Docket Number:	15-AFC-02
Project Title:	Mission Rock Energy Center
TN #:	215103
Document Title:	Mission Rock Energy Center Data Request Responses Set 1A Supplement
Description:	DR Set 1A Supplement
Filer:	M. Finn
Organization:	CH2M
Submitter Role:	Applicant Consultant
Submission Date:	12/22/2016 4:12:26 PM
Docketed Date:	12/22/2016

Responses to California Energy Commission Staff
Data Request Sets 1 and 1A - Supplemental Responses

Mission Rock Energy Center

15-AFC-02

Figure DR91-1
Import Fill Delivery Route
 Mission Rock Energy Center
 Ventura County, California

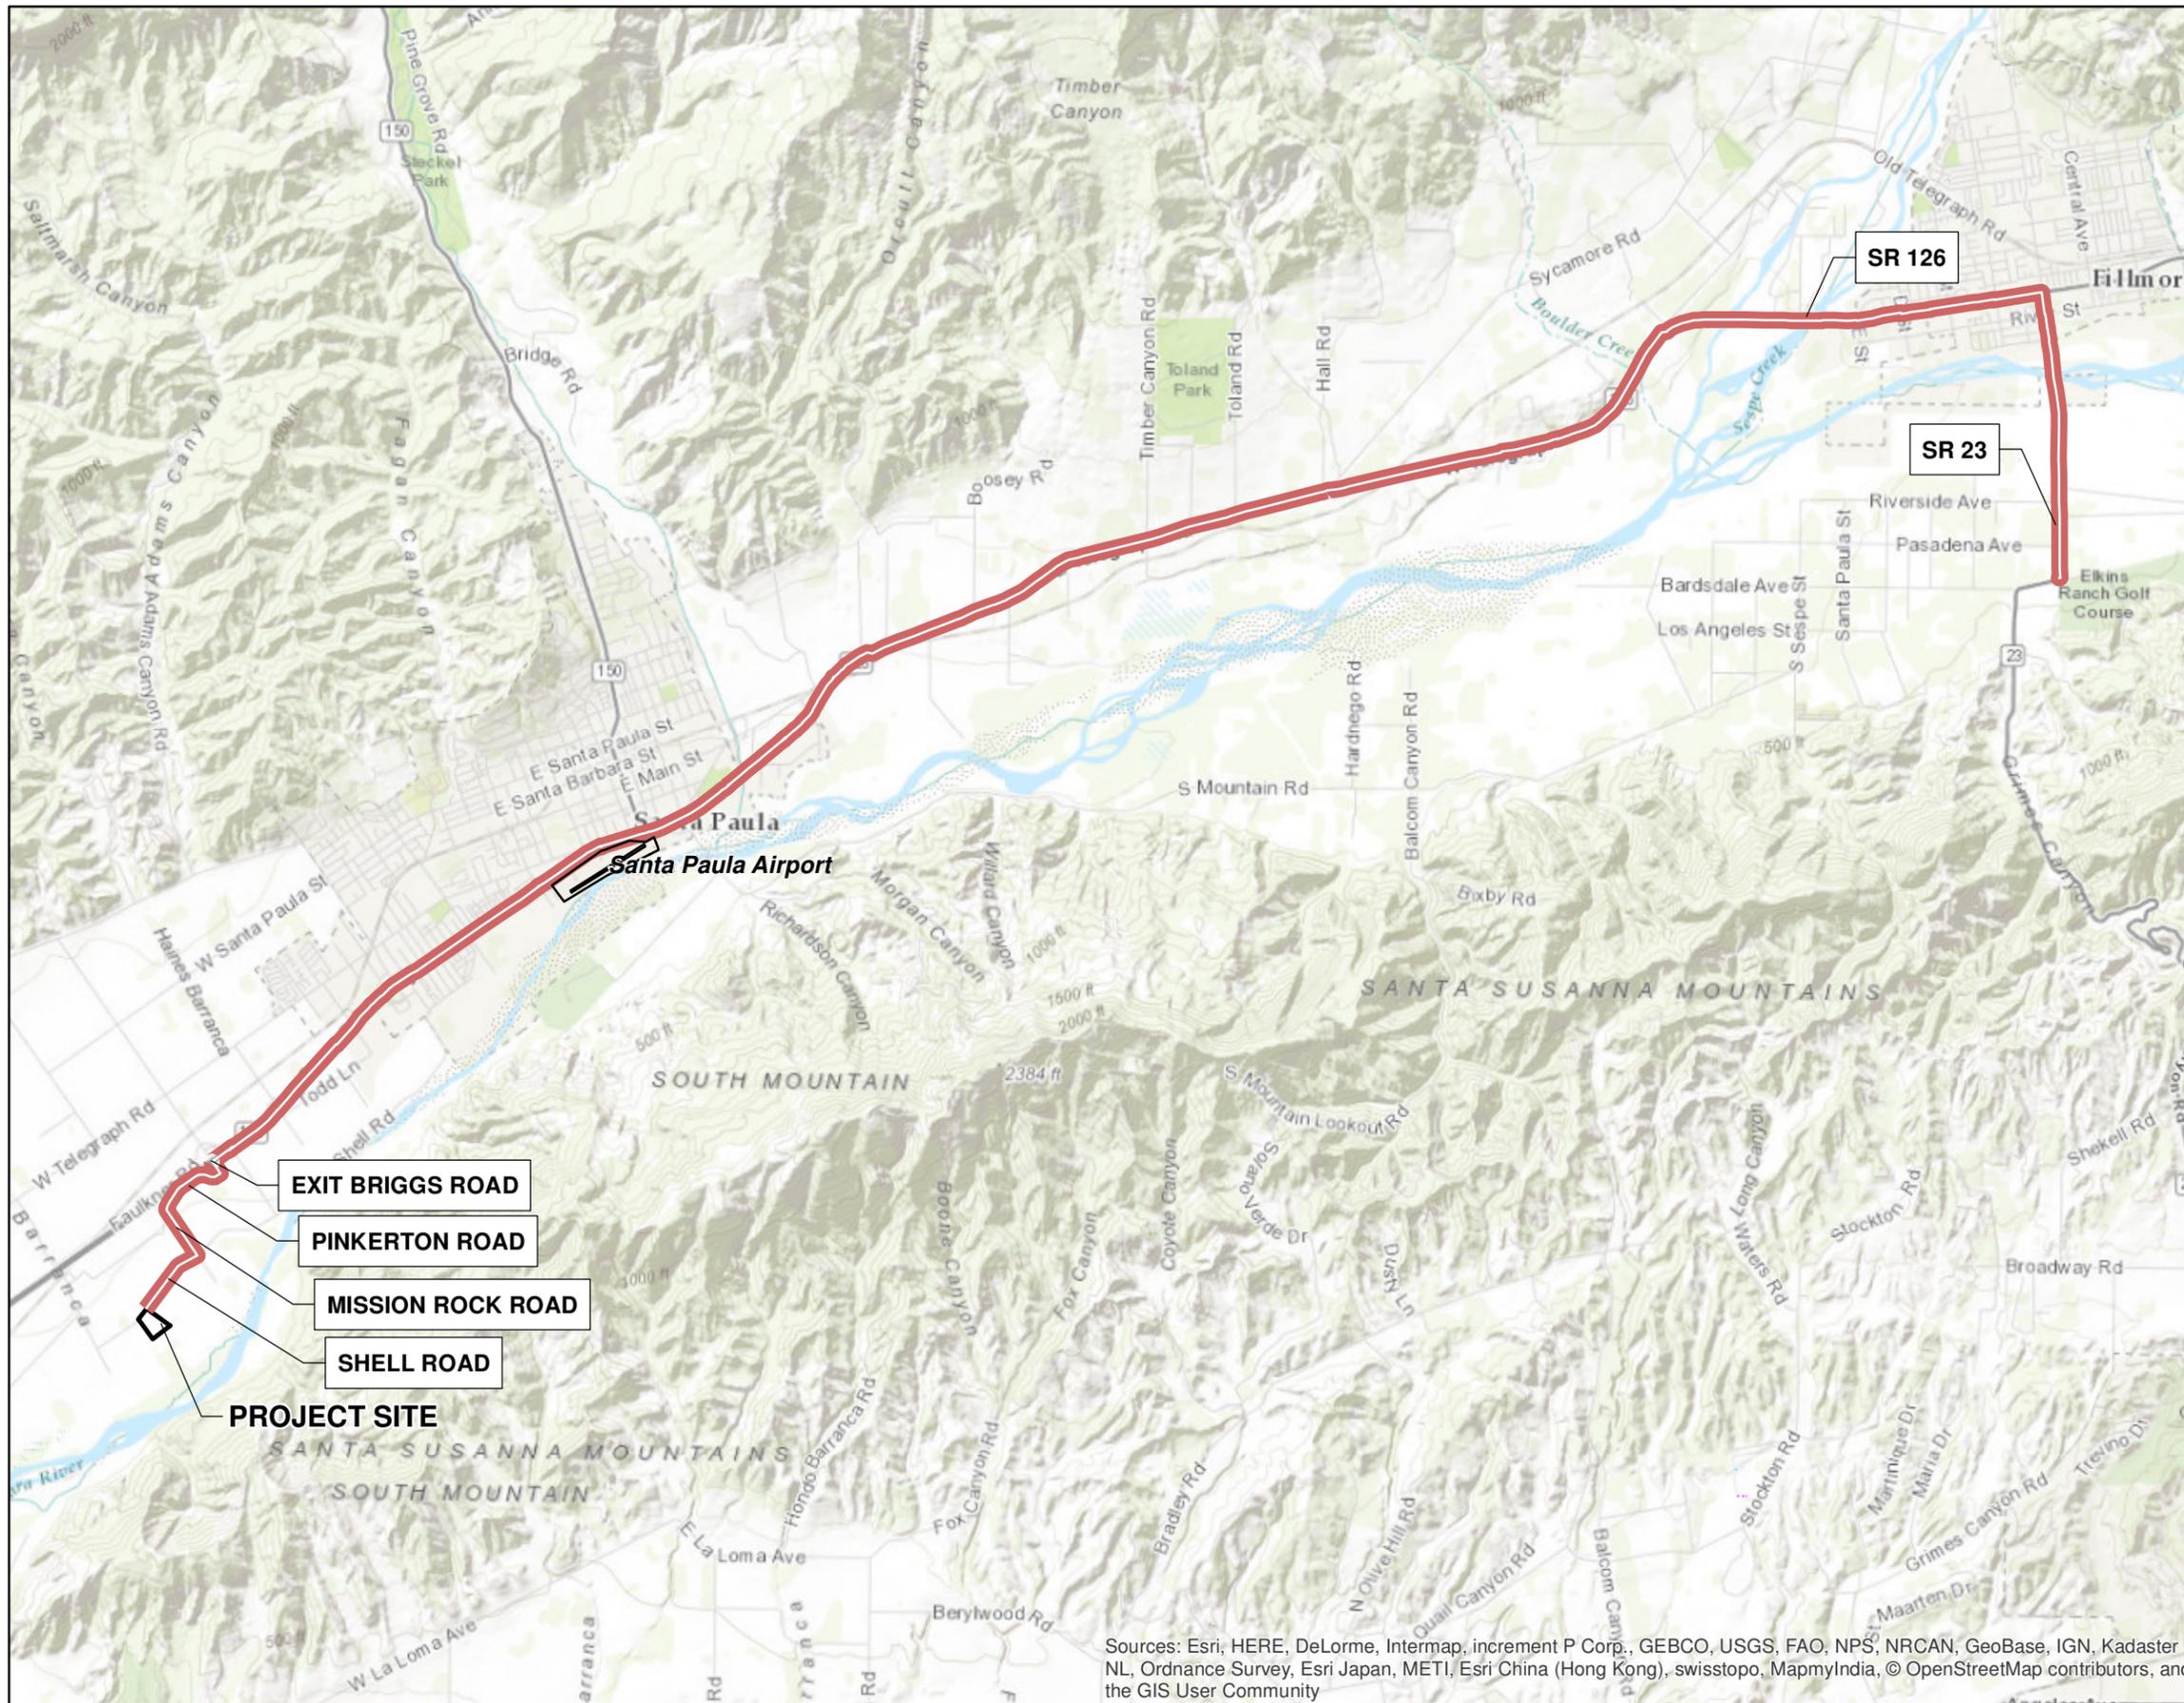
91. *Please provide the full imported fill soil delivery route from source to site, including respective roadway segment/ intersection LOS analysis for any roadway segment or intersection not previously addressed in the AFC*

Response: During months 2 through 6 (five months total) of construction, trucks will be importing fill from the borrow site in Fillmore, located on State Route (SR) 23 (Grimes Canyon Road), approximately 18 miles northeast of the site. To access the quarry, trucks will travel on SR 126 and 23, which are both designated truck routes within the City of Fillmore. Trucks will leave quarry and travel northeast on SR 23 (Grimes Canyon Road), turn left (westbound) onto SR 126 and exit SR 126 at Briggs Road. Trucks will turn left onto Briggs Road (southbound); turn right onto Pinkerton Road (westbound), turn left (southbound) onto Mission Rock Road and then right (westbound) onto Shell Road. Trucks will use the project driveway on Shell Road. The truck route is illustrated in Attachment DR91-1, Import Fill Delivery Route. This route description and figure were provided in a previous response for DR 91, but are included again for convenience.
